City of Canby

Utility Notes

American Welding

March 24, 2022

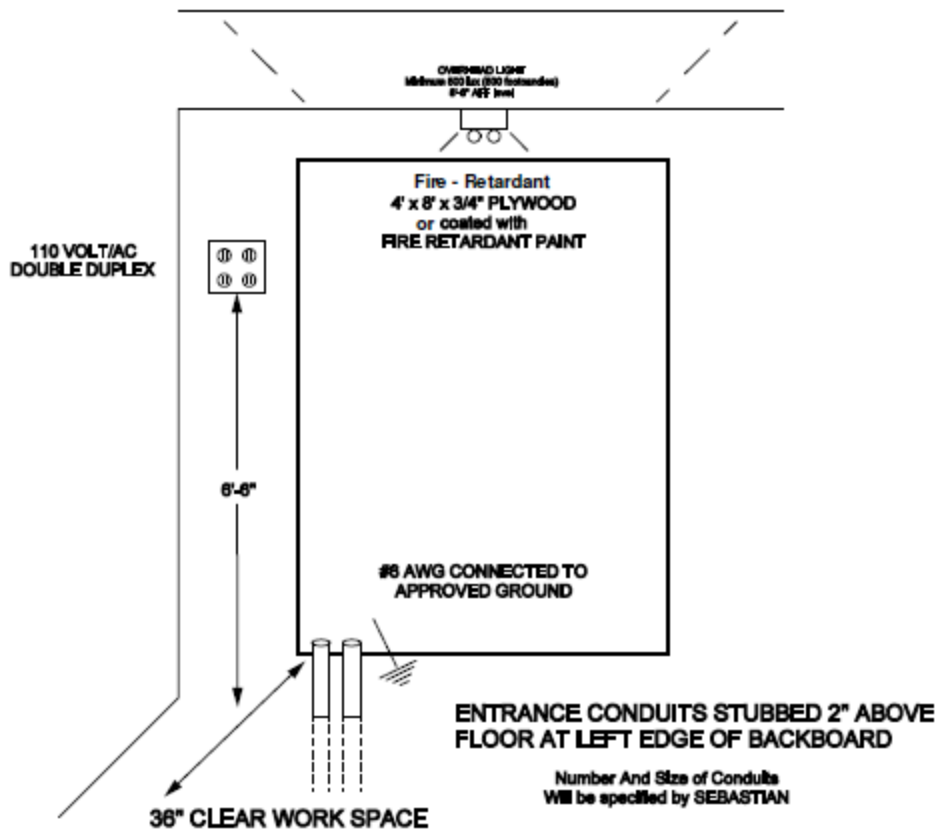
- The Developer/Owner is required to provide all trenches for placing underground communication facilities from the existing connection point. We will place and provide all materials.

- We will follow the power design as much as possible to minimize trenching; however, a separate trench may be required for communication services.
- If the D-marc is required to be placed in a communication / power room, the requirements are:

1. 2" schedule 40 PVC from the telephone connection point outside, into the Communication / power room with a 36" sweep (minimum).
 2. One 4'x8' 3/4" plywood backboard or coated with fire retardant paint.

3. #6 stranded grounds (MGN) connected to approved ground provided at the backboard.
 4. One 15 Amp electrical outlet located next to / or on backboard.
